SUBJECT: ISSUANCE OF AMENDMENT (TAC NO. 68198)

The Commission has issued the enclosed Amendment No. 124 to Provisional Operating License No. DPR-16 for the Oyster Creek Nuclear Generating Station, in response to your application dated May 10, 1988.

The amendment would revise Technical Specification Sections 3.2.C, 4.2.E and 6.9.3 to reflect the use of an enriched sodium pentaborate solution in the standby Liquid Control System (SLCS).

Amendment No. 124
License No. DPR-16

Fig. 3.2-1 Sodium Pentaborate Solution Volume - Concentration Requirement

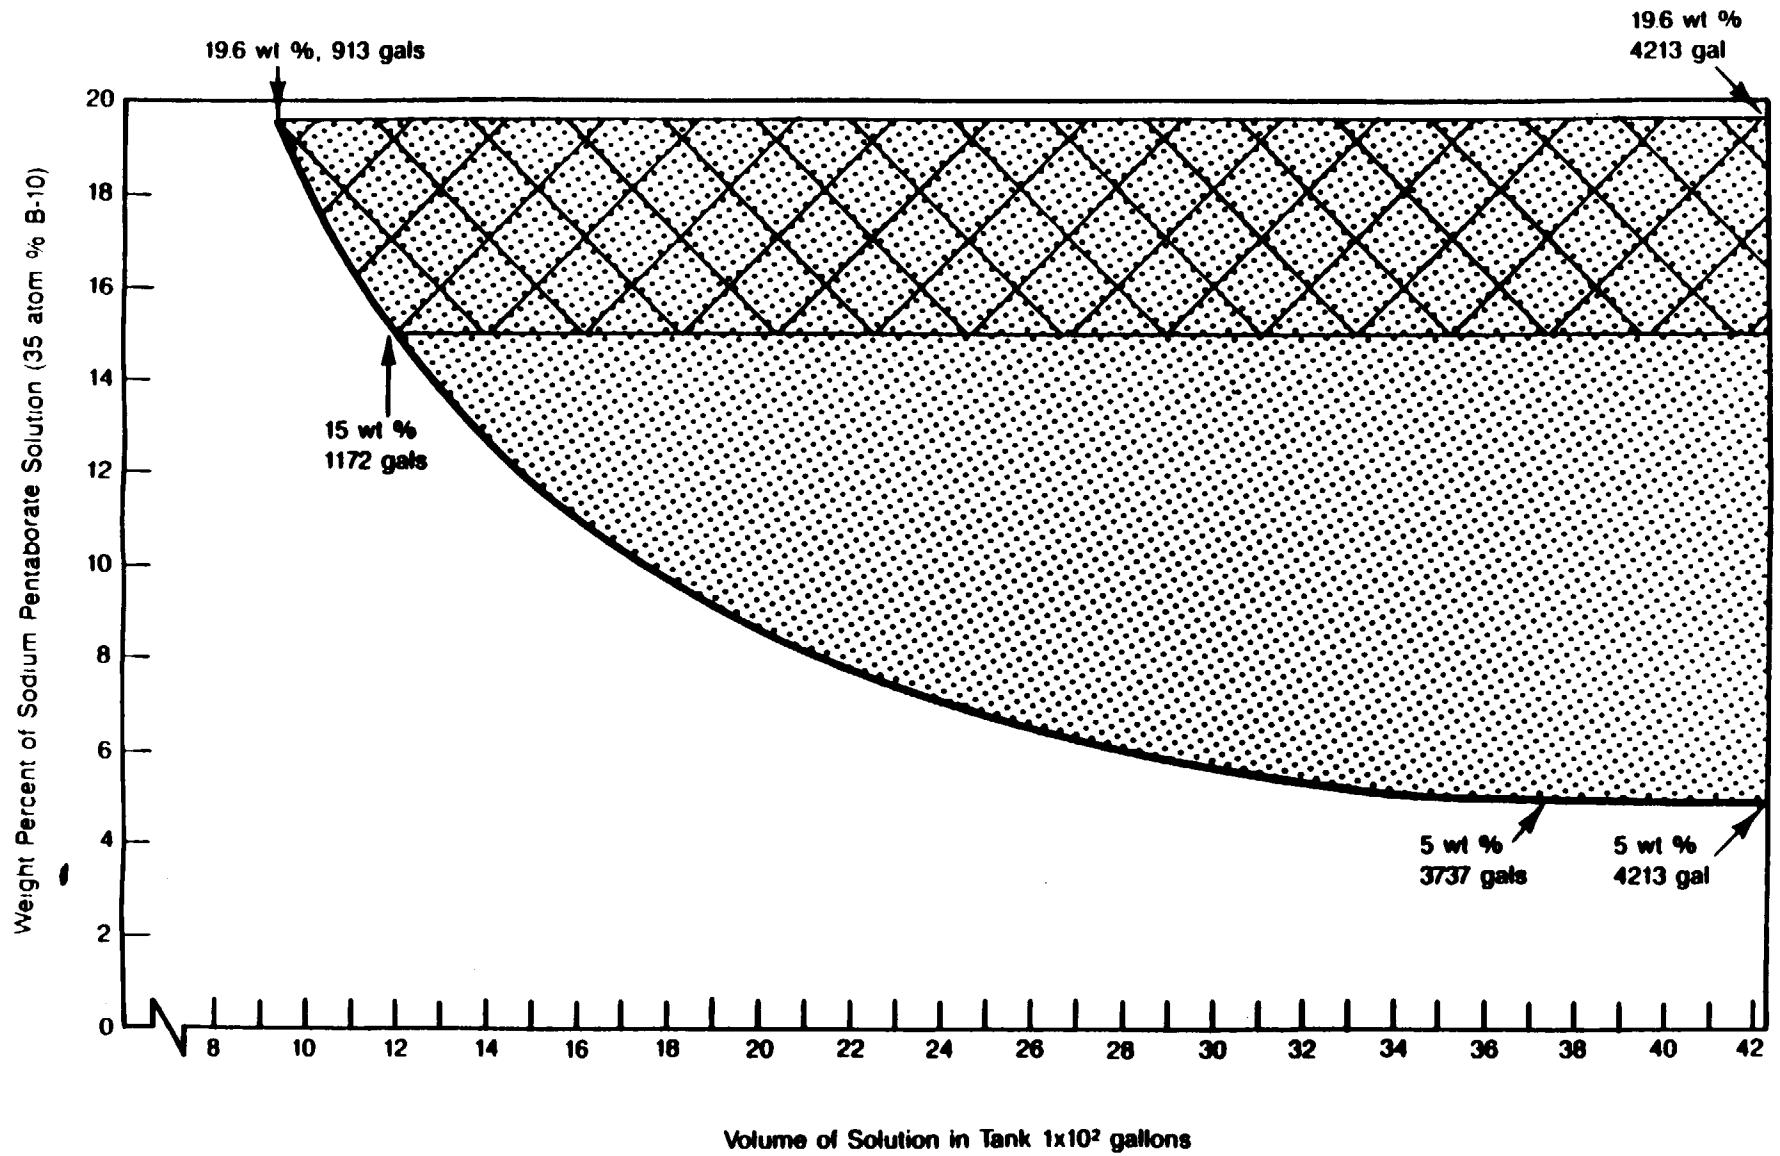
2. The standby liquid control solution shall have a Boron-10 isotopic enrichment equal to or greater than 35 atom %, be maintained within the crosshatched volume-concentration requirement area in Figure 3.2-1 and at a temperature not less than the temperature presented in Figure 3.2-2 at all times when the standby liquid control system is required to be operable.

- (b) If the solution is outside the crosshatched volume-concentration area but within the shaded volume-concentration area of Figure 3.2-1, return the solution to the crosshatched area within 7 days. If after this time period the requirement is still not met, submit a report to the NRC within 7 days advising them of plans to return the solution to the crosshatched volume-concentration area.

- (c) If the solution is outside the crosshatched volume concentration area and outside the shaded volume-concentration area of Figure 3.2-1, return the solution to within the shaded volume-concentration area of Figure 3.2-1 or be in the Shutdown condition within 24 hours.

Because Figure 3.2.1 has been revised to reflect the increased Boron-10 isotopic enrichment, an additional requirement has been added to evaluate the solution's capability to meet the original design shutdown criteria whenever the Boron-10 enrichment requirement is not met.

The system description provided by GPUN for Oyster Creek has been reviewed by the staff against the requirements of the ATWS Rule (10 CFR 50.62), and Generic Letter 85-03, "Clarification of Equivalent Control Capacity for Standby Liquid Control Systems," dated January 28, 1985. The licensee will increase the boron enrichment to a minimum of 35 atom percent of B-10, and proposes to supply 30 gpm of a minimum 15 weight percent of sodium pentaborate solution to the reactor vessel. Accounting for the physical size of the Oyster Creek reactor vessel which is 213 inches inside diameter, the aforementioned flow/enrichment combination satisfies the ATWS Rule equivalency requirement which is based upon 86 gpm pump flow, 13 weight percent sodium pentaborate and 19.8 atom percent B-10, and a 251 inch diameter vessel, as discussed in Generic Letter 85-03. The proposed design is therefore acceptable. The new limits are reflected in the proposed Technical Specification Sections 3.2.C.2, 3.2.C.3, Figure 3.2-1 and Figure 3.2-2.

The shaded area of Figure 3.2-1 represents the acceptable values of liquid control tank volume and solution concentration which assure that, with one 30 gpm liquid control pump, the reactor can be brought to the cold shutdown condition from a full power steady state operating condition at any time in core life independent of the control rod system capabilities. The crosshatched area of Figure 3.2-1 represents the acceptable values of liquid control tank volume and solution concentration which assure that the equivalency requirements of 10CFR50.62 are satisfied. The maximum volume of 4213 gal is established by the tank capacity. The tank volume requirements include consideration for 137 gal of solution which is contained below the point where the pump takes suction from the tank and, therefore, cannot be inserted into the reactor.

**FIGURE 3.2.2 - Sodium Pentaborate Solution
Temperature Requirements**

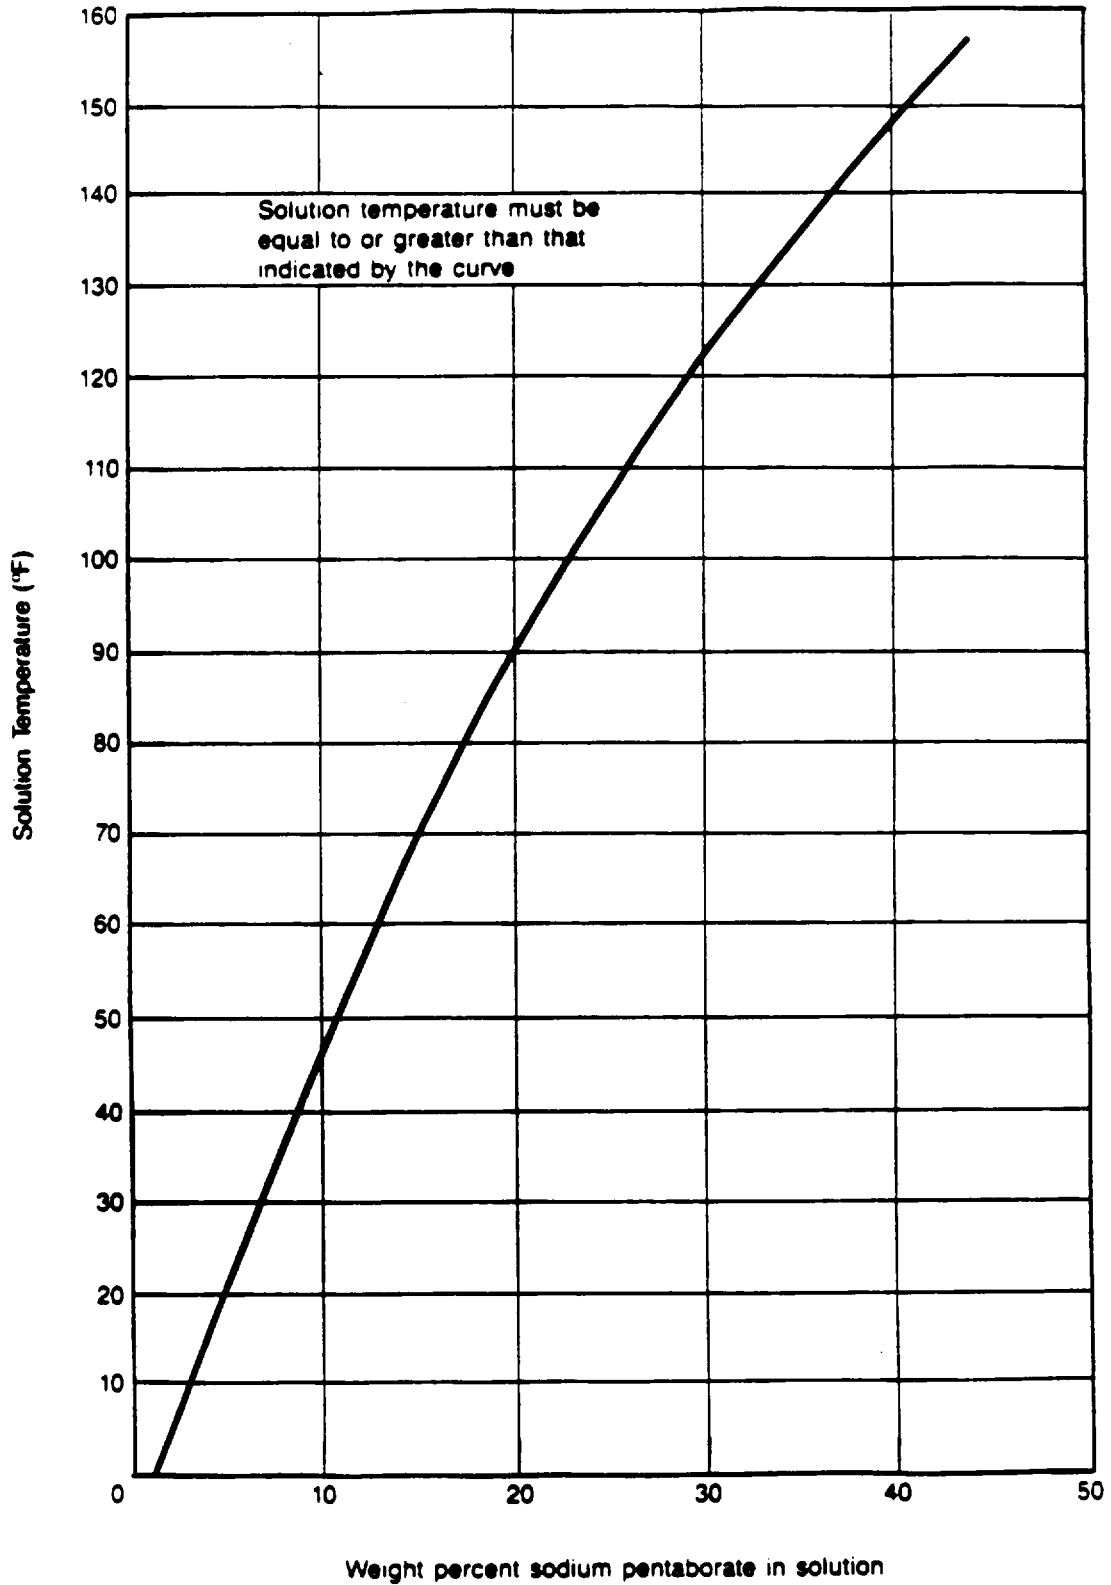
- (d) If the solution temperature is less than the minimum shown in Figure 3.2-2, increase the temperature to greater than the minimum and verify the solution is within the shaded volume-concentration area of Figure 3.2-1 or be in the Shutdown condition within 24 hours.

The solution saturation temperature varies with the concentration of sodium pentaborate. The solution will be maintained at least 5°F above the saturation temperature to guard against precipitation. The 5°F margin is included in Figure 3.2-2. Temperature and liquid level alarms for the system are annunciated in the control room.
